DATE: February 17, 2026
TO: ALL CONTRACTORS
FROM: DUSTINE TILL
PROJECT: ROSCOE ROAD WATER TREATMENT PLANT
ORANGE BEACH WATER AUTHORITY
GMC PROJECT NO. CMOB230049
RE: ADDENDUM #3

ADDENDUM NUMBER 3

ROSCOE ROAD WATER TREATMENT PLANT

GMC PROJECT NO. CMOB230049

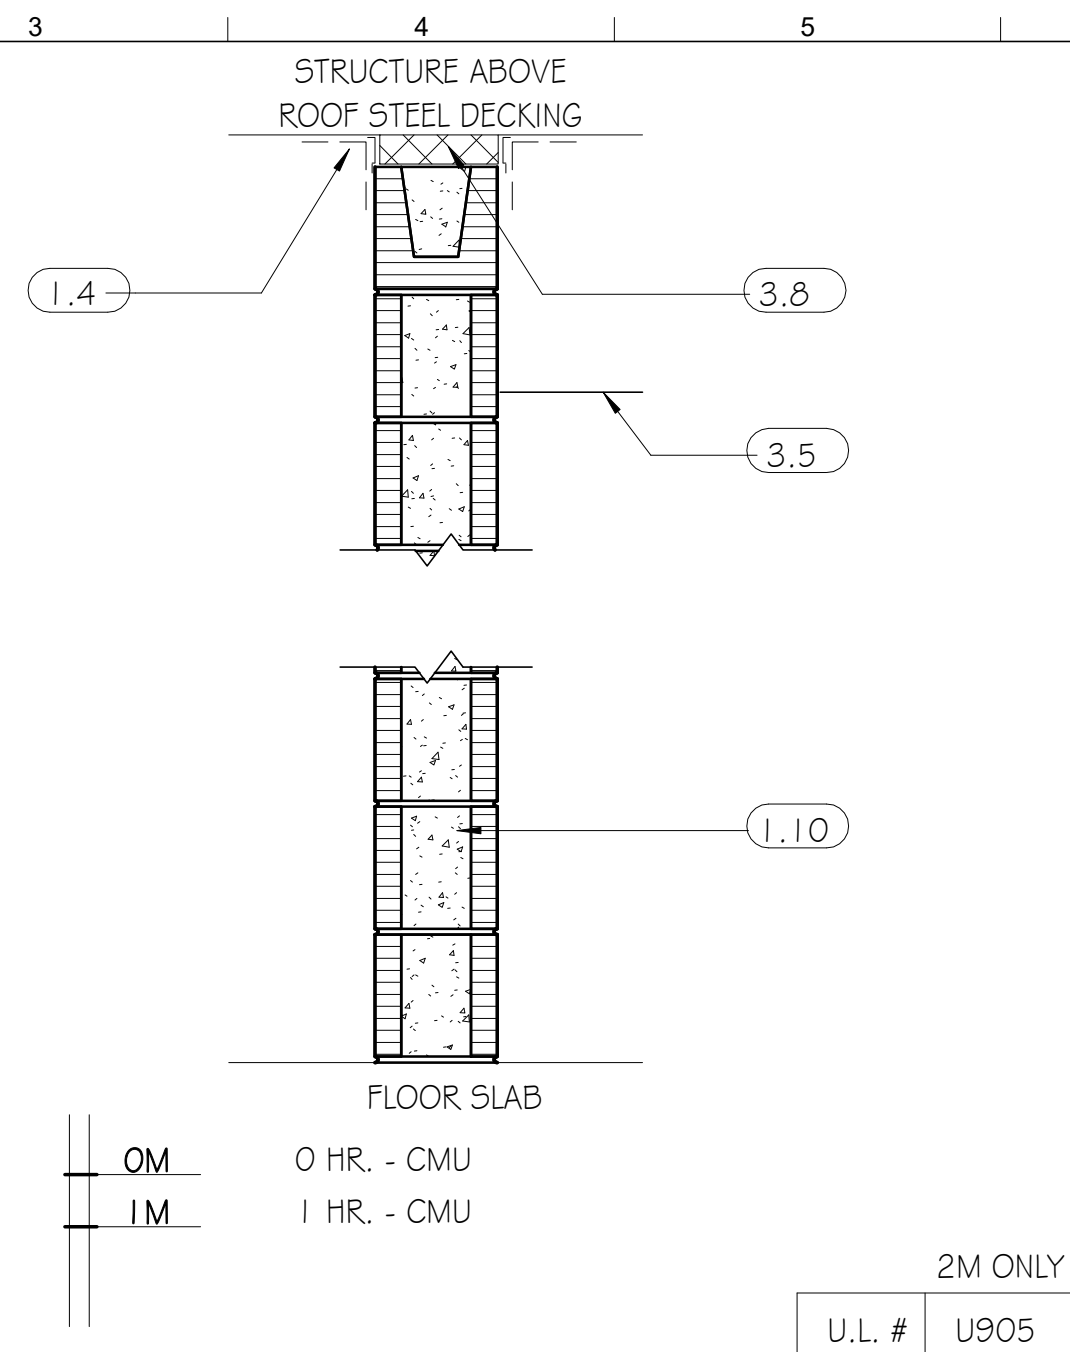
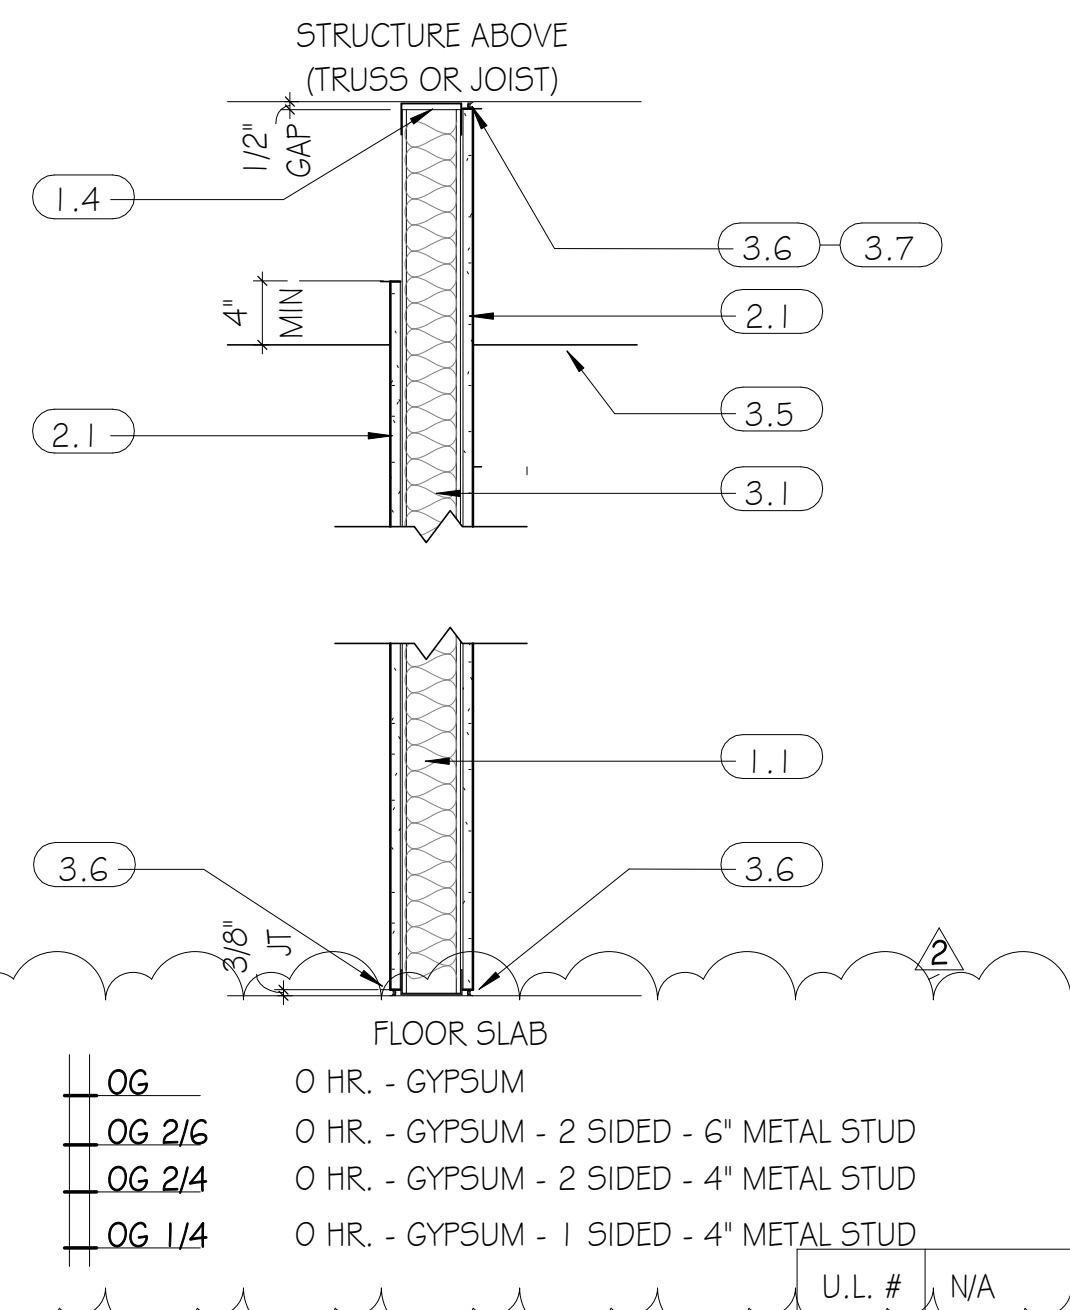
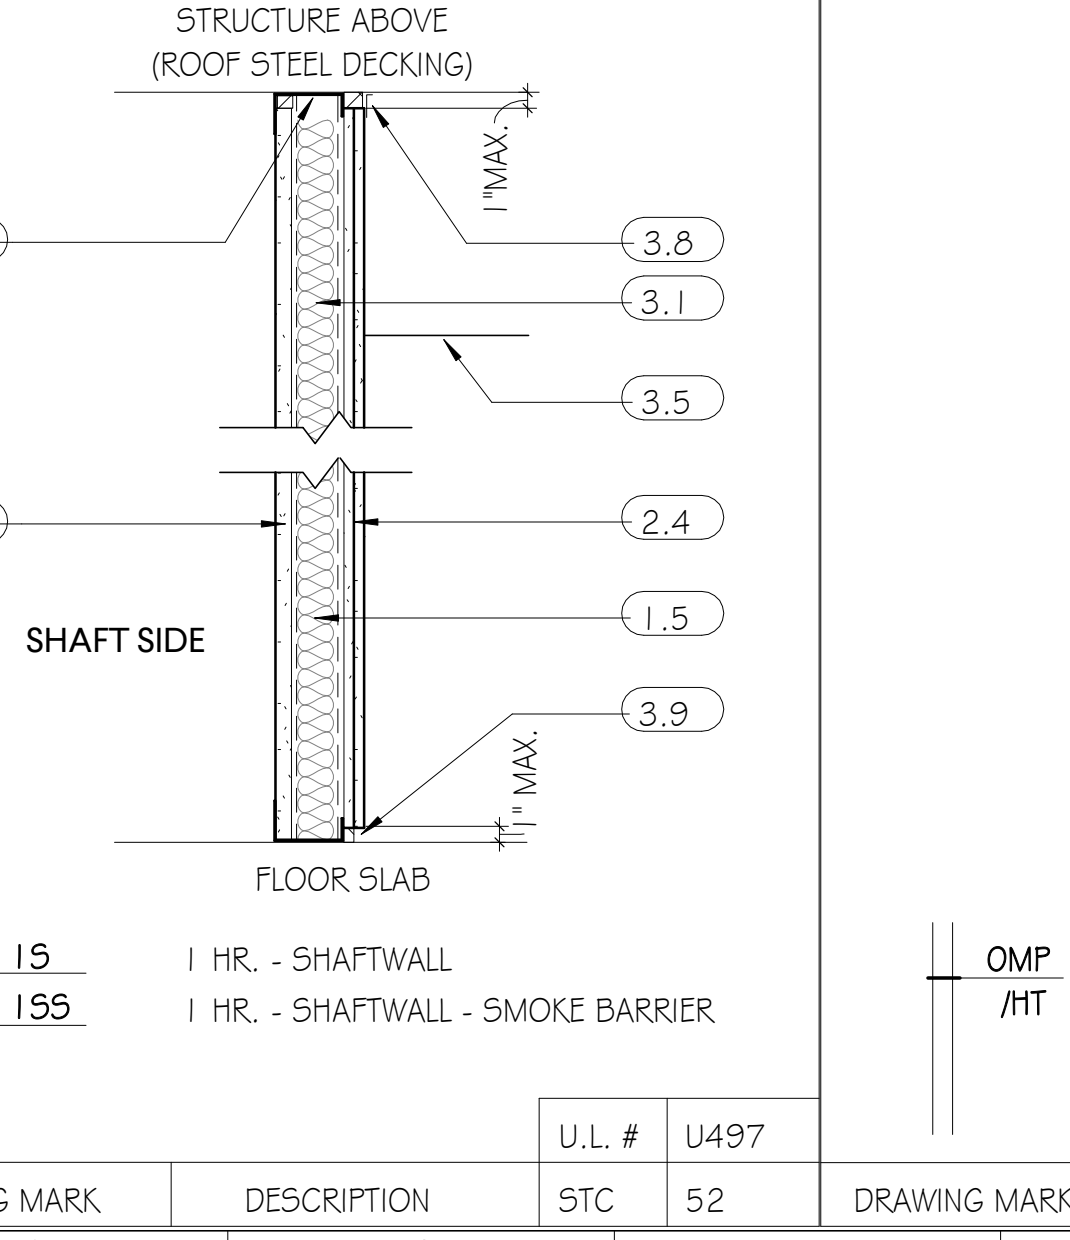
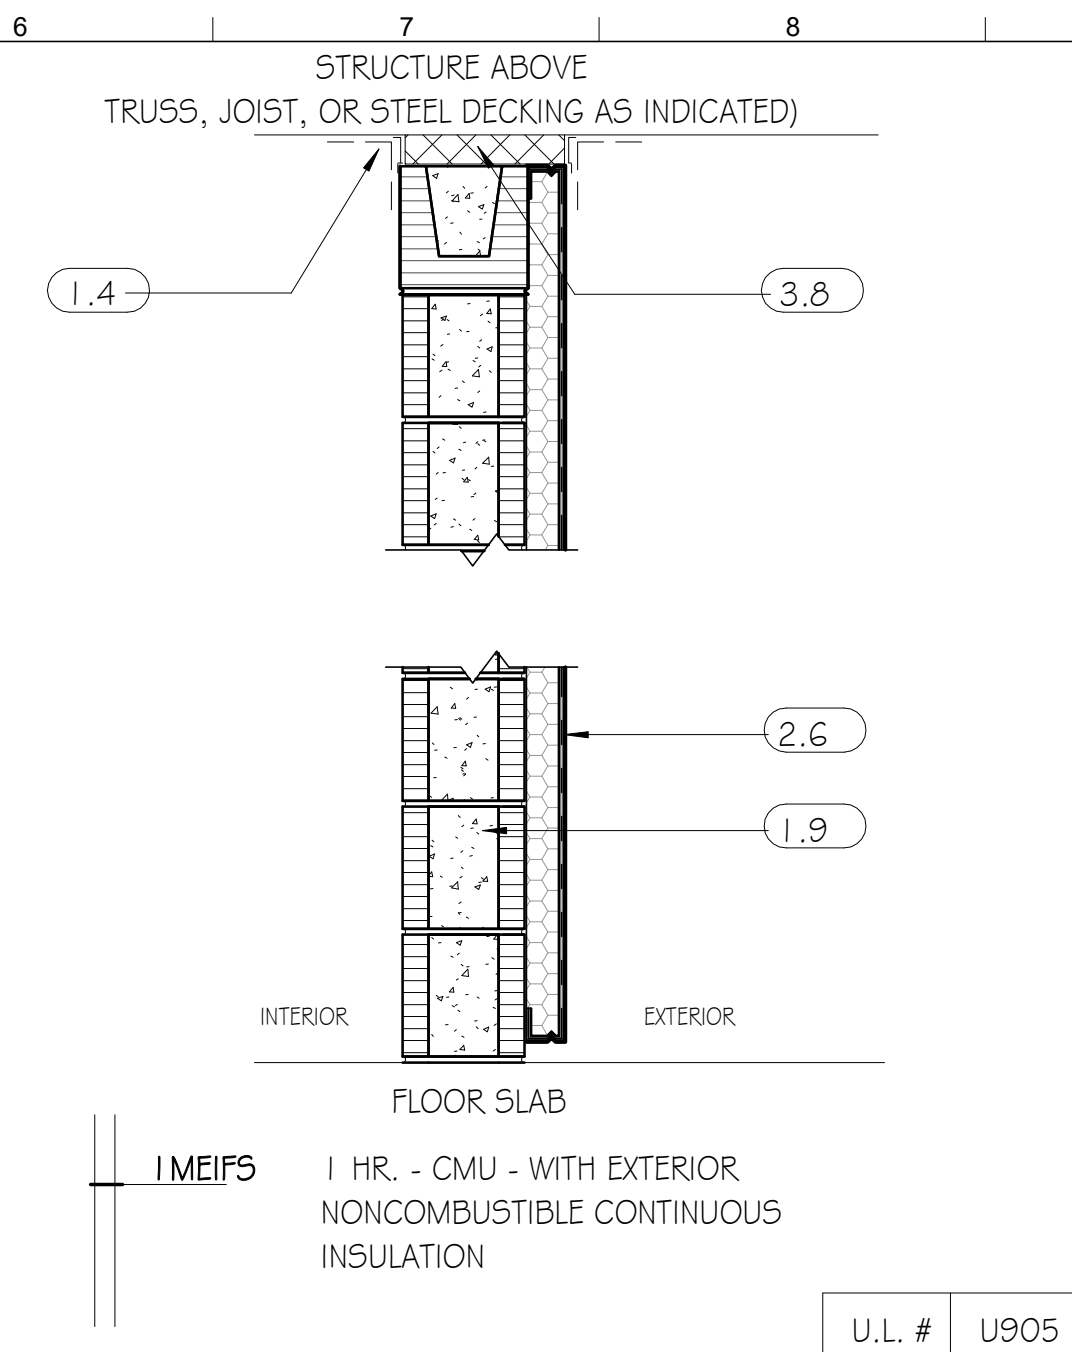
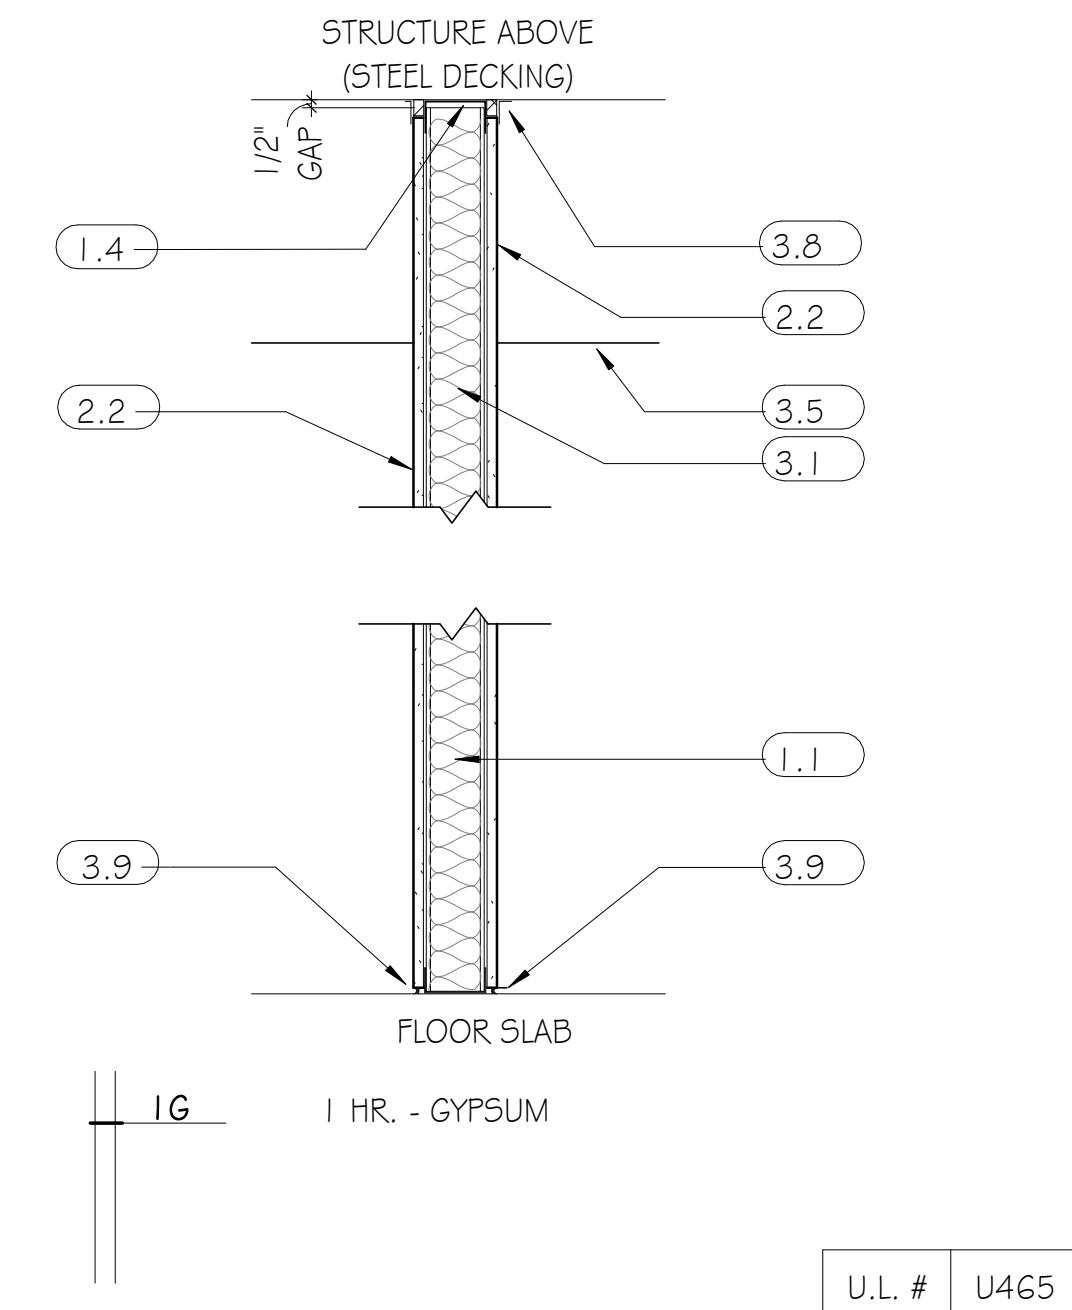
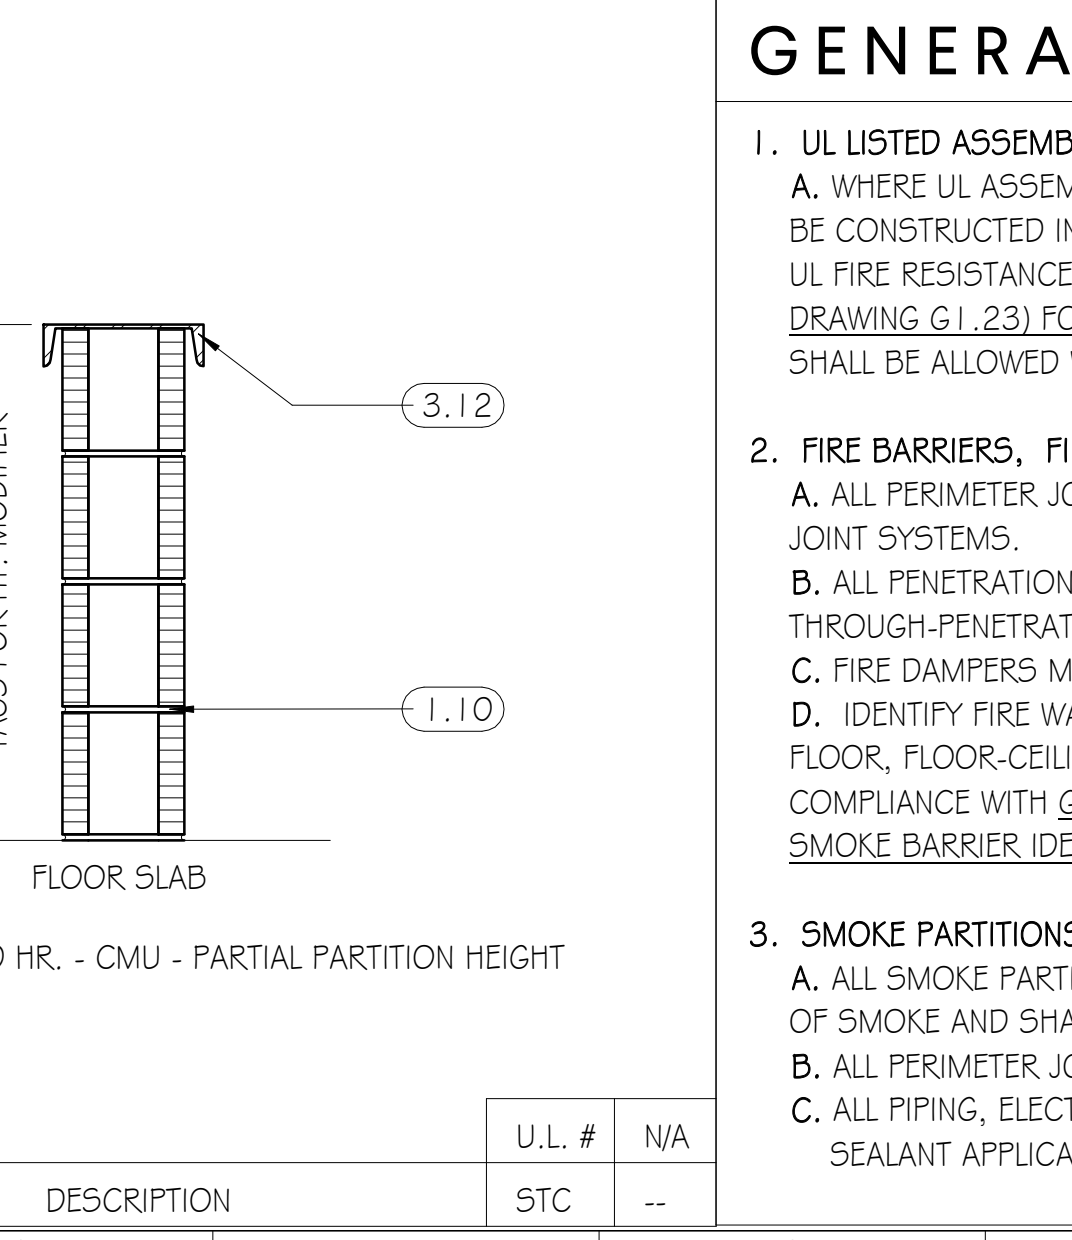
Answer: Yes, the 24” wide, 24 gauge, 2-coat Kynar roof panels shall be used for both.
- 5.62 **Question: Drawing A-722 shows several wall types, OG2/6”, OG2/4” and OG1/4”. These types are not shown in the details on A-707. What does the description mean?**

Answer: Refer to PARTITION KEY on Sheet A-707 for provided partition breakdowns. “0” = zero fire rating, “G” = gyp board, “2” = gypsum board on 2 sides, “1” = gypsum board on 1 side, “6” = 6” metal stud, “4” = 4” metal stud.
